Amendments to the drawings:

Figs. 1-6 have been amended to conform with the requirements of 37 C.F.R. §§ 1.83 and 1.84. Amended marked-up drawings and the proposed replacement drawings have been included with this amendment.

Fig. 1

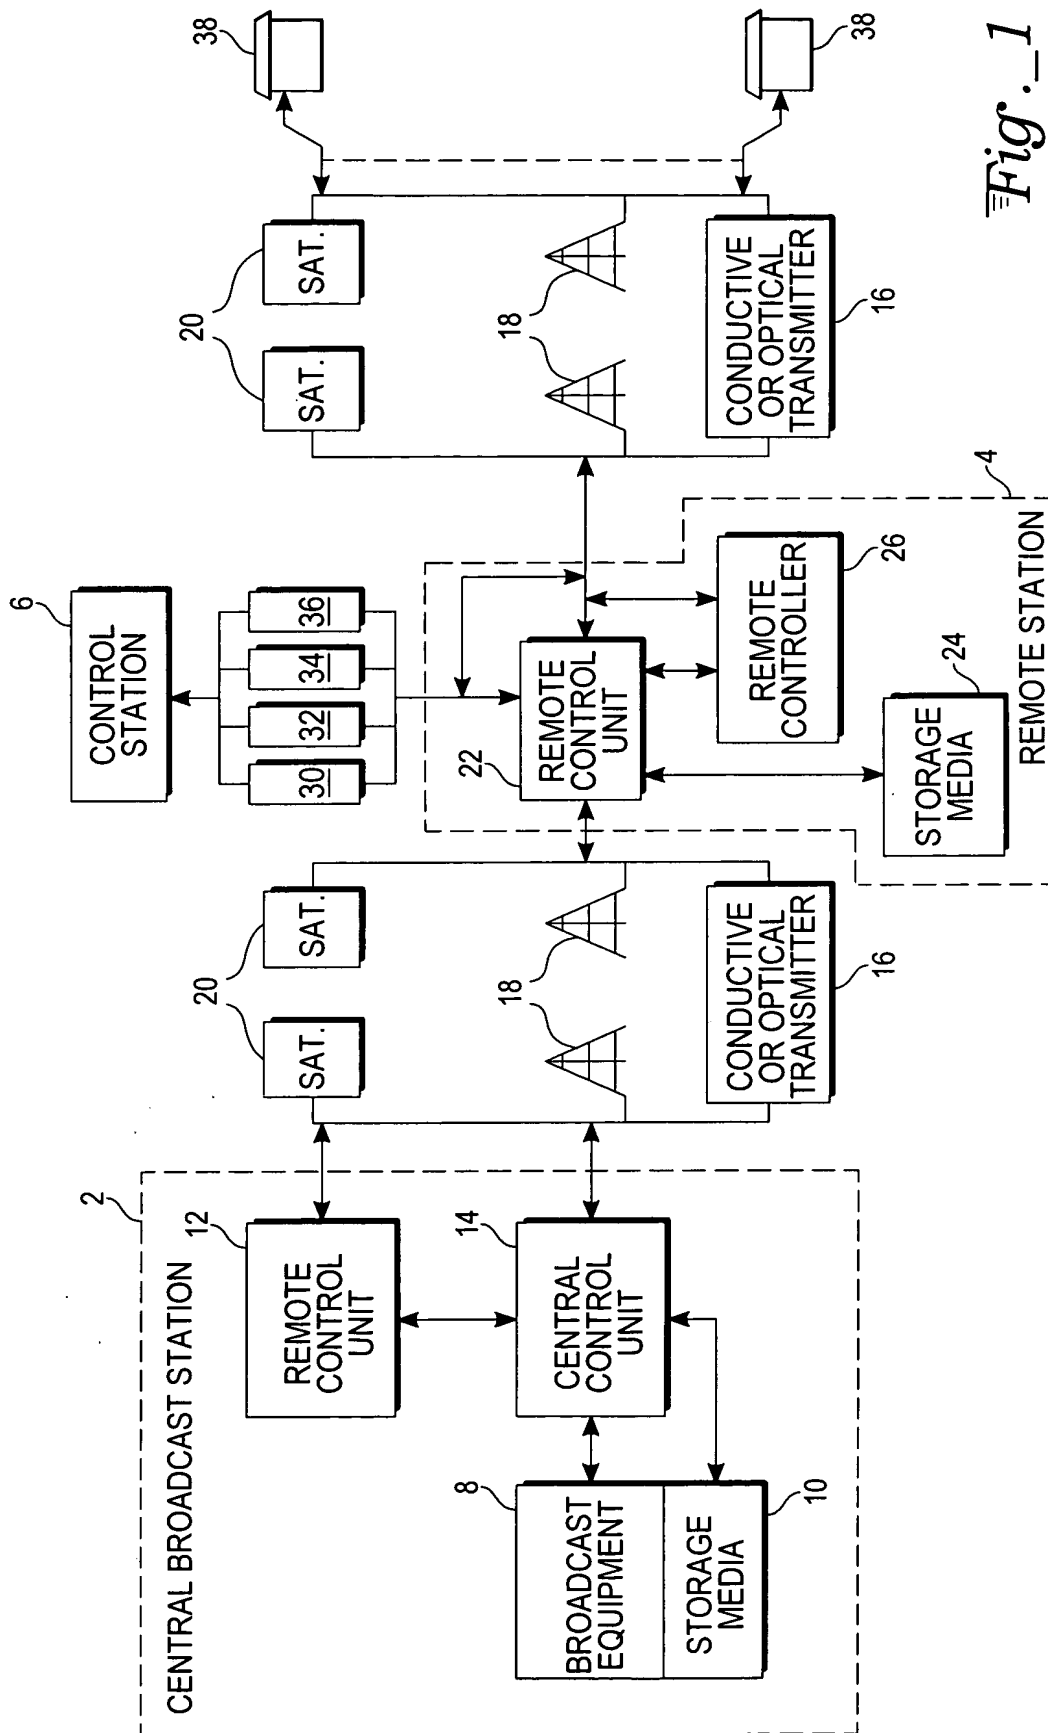
In Figs. 1-5, Applicants propose to add labels to blocks in the diagrams and, where indicated in the marked-up versions of the drawings, remove reference numerals from their location inside the blocks to new locations outside the blocks with lead lines to the referenced blocks. In Figs. 1-5, the lead lines have also been changed so that they do not enter the referenced block and, where indicated in the marked-up versions of the drawings, the location of some of the reference numerals has been changed. In Fig. 1, lead lines for reference 20 have been changed to 2 single lines rather than a plurality of lines. In Fig. 6, the font size of the text has been increased and the text has been capitalized. Applicants believe the replacement drawings now conform with the requirements of 37 C.F.R. §§ 1.83(a) and 1.84(o) and requests these changes be accepted.
